CITY OF PUYALLUP
Planning Division Approved Site Plan
(253) 864-4165
MINIMUM SETBACK REQUIREMENTS
Front Yard: 12 ft Rear Yard: 10 ft
Interior Side Yard: 6 ft Left Right: 6 ft
Street Side Yard: 12 ft
Zoning District: UCX
Permit #: B-21-0905
Additional Conditions/Comments
Permit for building addition and
MX-DRO administrative design review
only. Landscaping and parking area
changes will be reviewed under
separate civil permit.
Staff: RNBrown
Date: 04/18/2022
Front, rear, and side yard property lines shall be
marked with string from surveying pins prior to footing
inspection.

Walmart
PUYALLUP, WA
310 31ST AVE SE
STORE NO: 02403-278
JOB NUMBER: WDP002403-278 PHOTO: PICKUP ENTINCMNT

PICKUP
DEMOLITION
&
SITE PLAN

SHEET:
CS1

DEMOLITION PLAN
APPROX. 1" = 20'

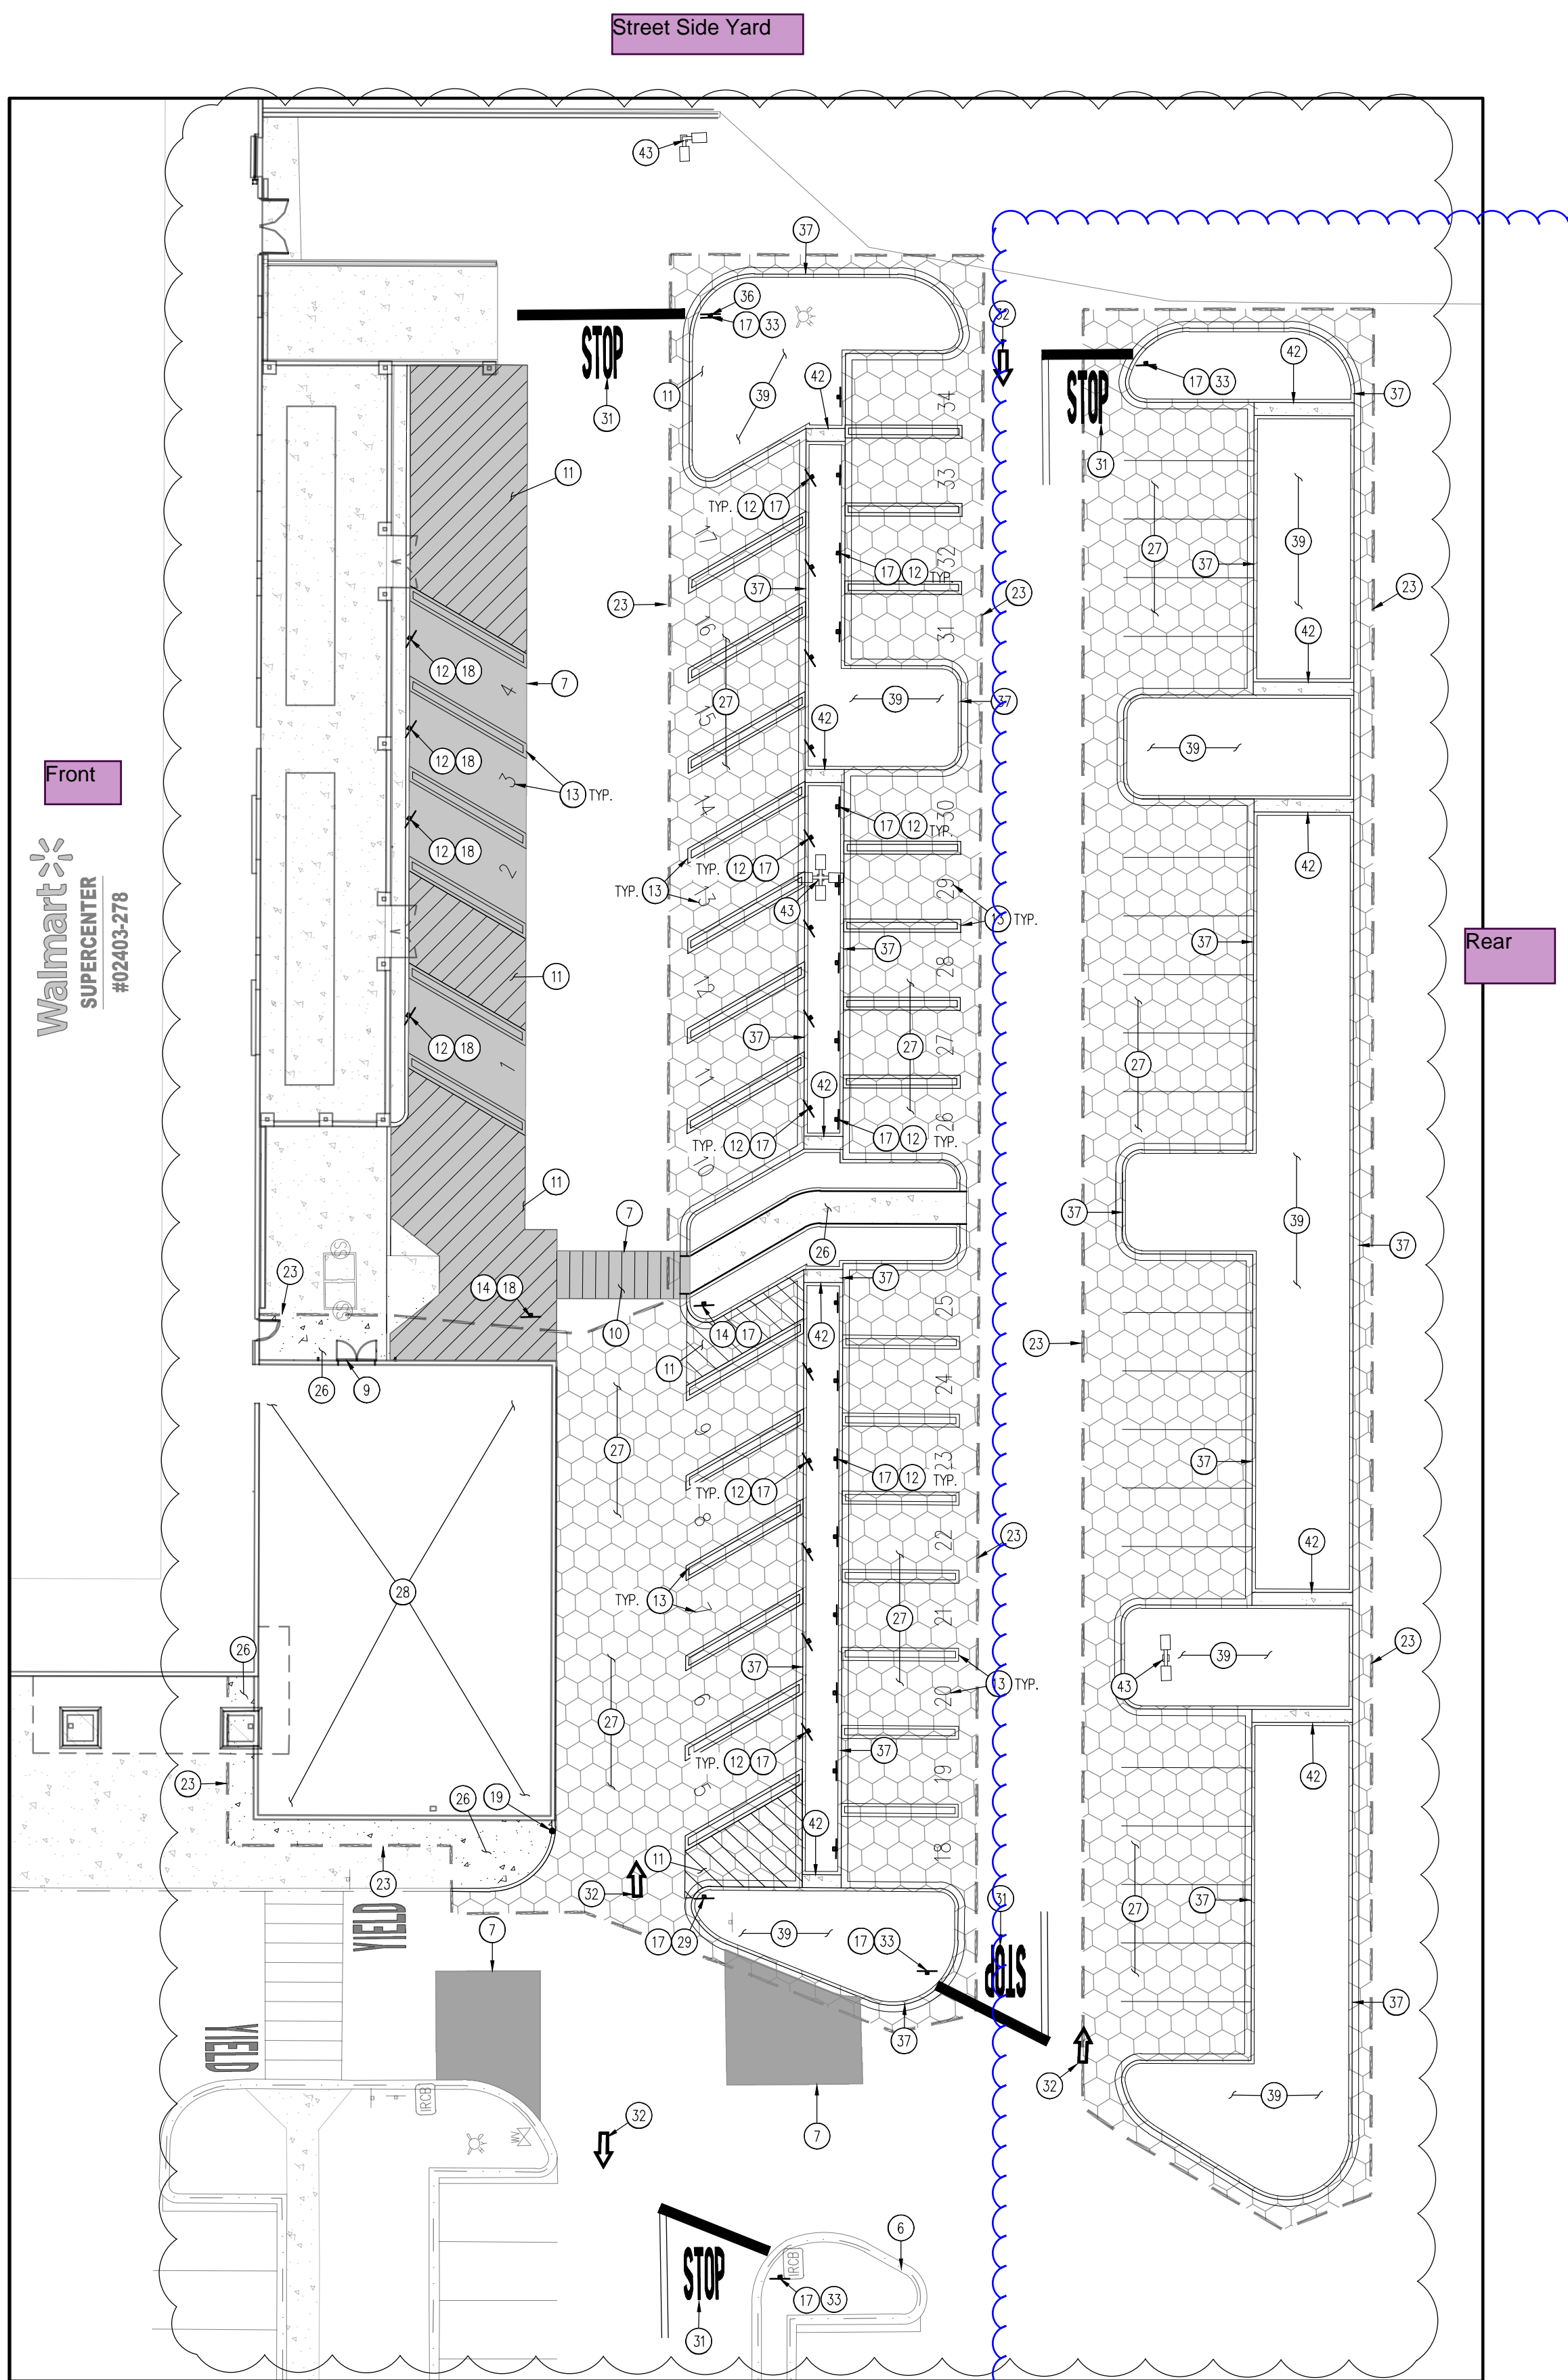
These proposed parking lot improvements
are not reflected on the civil plan set
submitted under application
PRCCP20220035. They must be removed
from this site plan or added to the civil plan
set. Pickup Demolition and Site Plan Sheet
CS1

SITE PLAN
APPROX. 1" = 20'

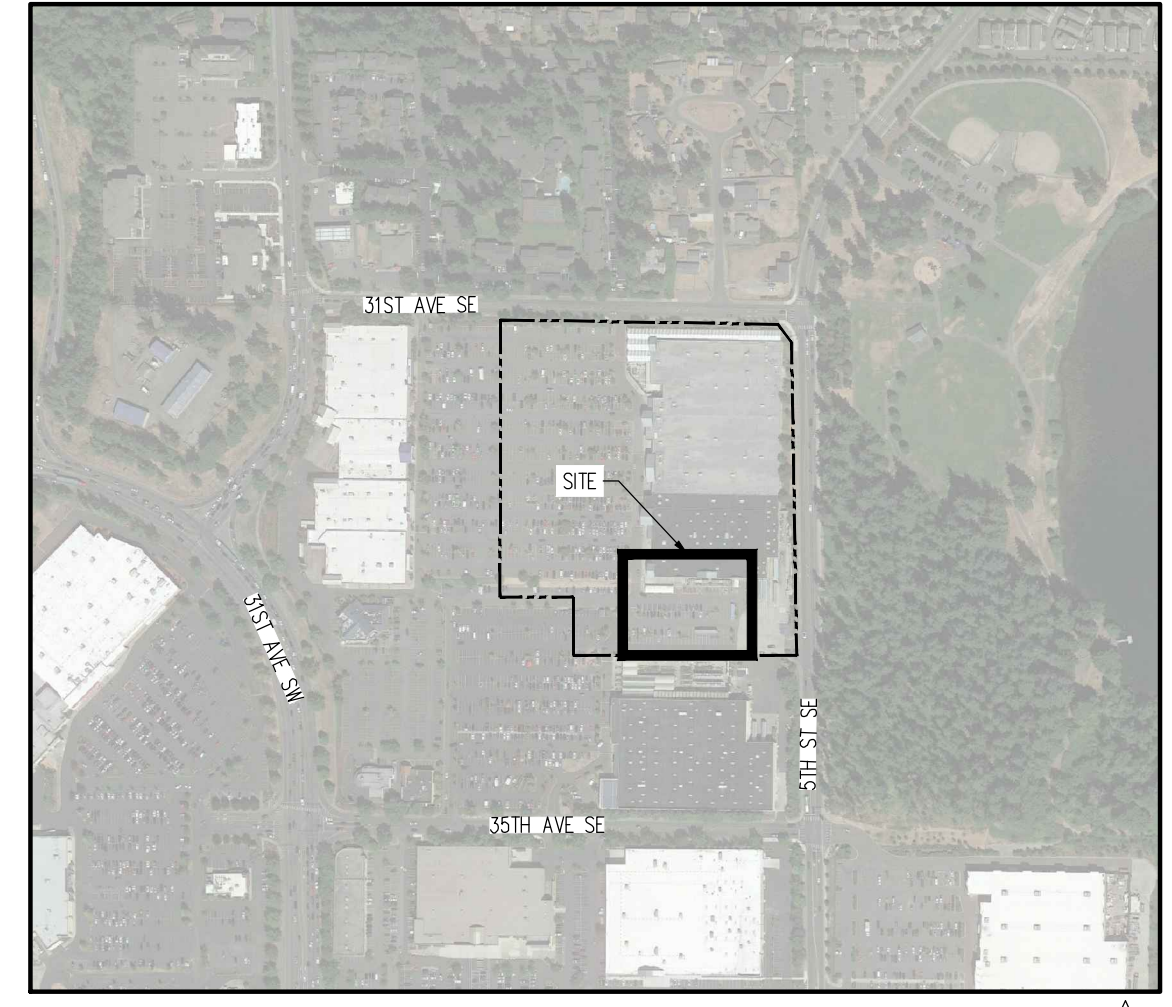
These proposed parking lot improvements
are not reflected on the civil plan set
submitted under application
PRCCP20220035. They must be removed
from this site plan or added to the civil plan
set. Pickup Demolition and Site Plan Sheet
CS1
